MADISON 2ND ADDITION

WICHITA, SEDGWICK COUNTY, KANSAS

S/D 98-71 - One-Step Final Plat of MADISON 2ND ADDITION

STAFF REPORT
(One-Step Final Plat-Approved 07/09/98)

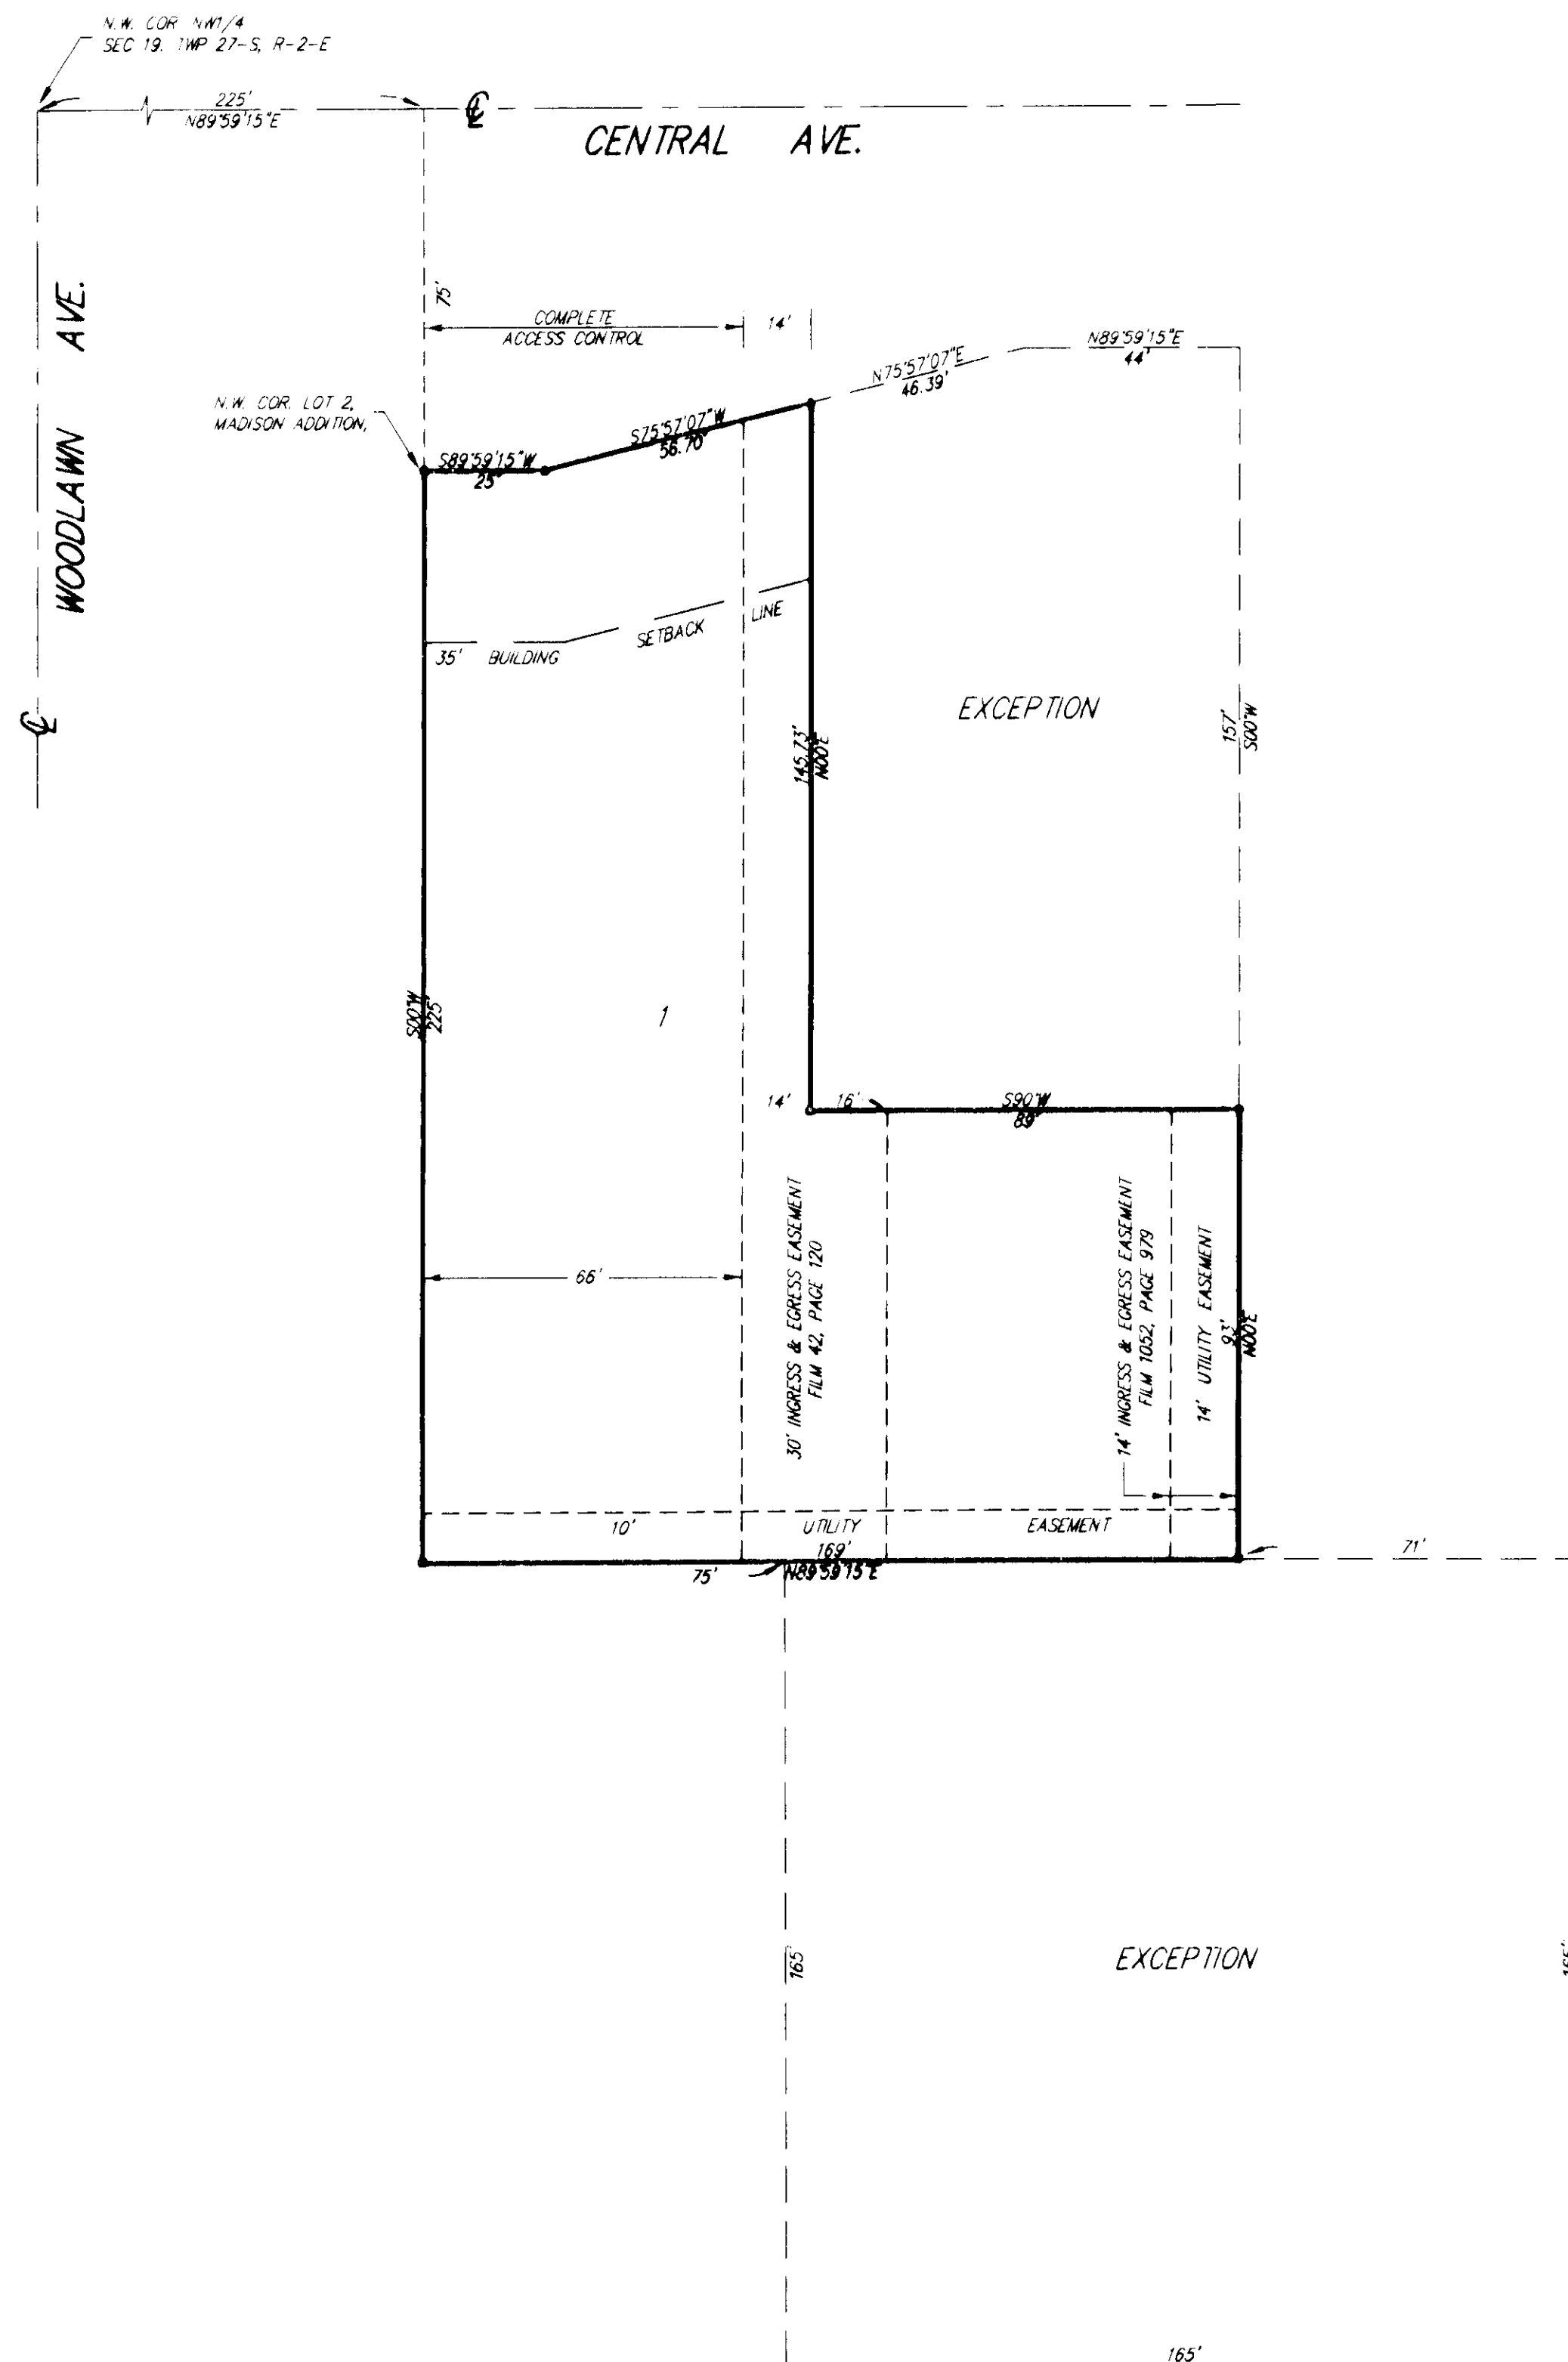
- C. City Engineering needs to comment on the status of the applicant's drainage plan.
- D. Sufficient access is provided through the shared opening with the plat to the east. The Applicant shall submit to MAPD the joint access easement.

- F. The applicant shall submit an avigational easement covering all of the subject plat and a restrictive covenant assuring that adequate construction methods will be used to minimize the effects of noise pollution in the habitable structures constructed on subject property.

- G. The legal description must be revised to correspond with the land being platted. The bearings for the east-west line between the plat and the exception area should be identical to those in the legal description.

- H. Traffic Engineering needs to comment on the need, if any, for improvements to Central.
- I. The applicant shall install or guarantee the installation of all utilities and facilities which are applicable and described in Article 8 of the MAPC Subdivision Regulations. (Water service and fire hydrants required by Article 8 for fire protection shall be as per the direction and approval of the Chief of the Fire Department.)

- P. The representatives from the utility companies should be prepared to comment on the need for any additional utility easements to be platted on this property.

KG&E has requested additional easements.
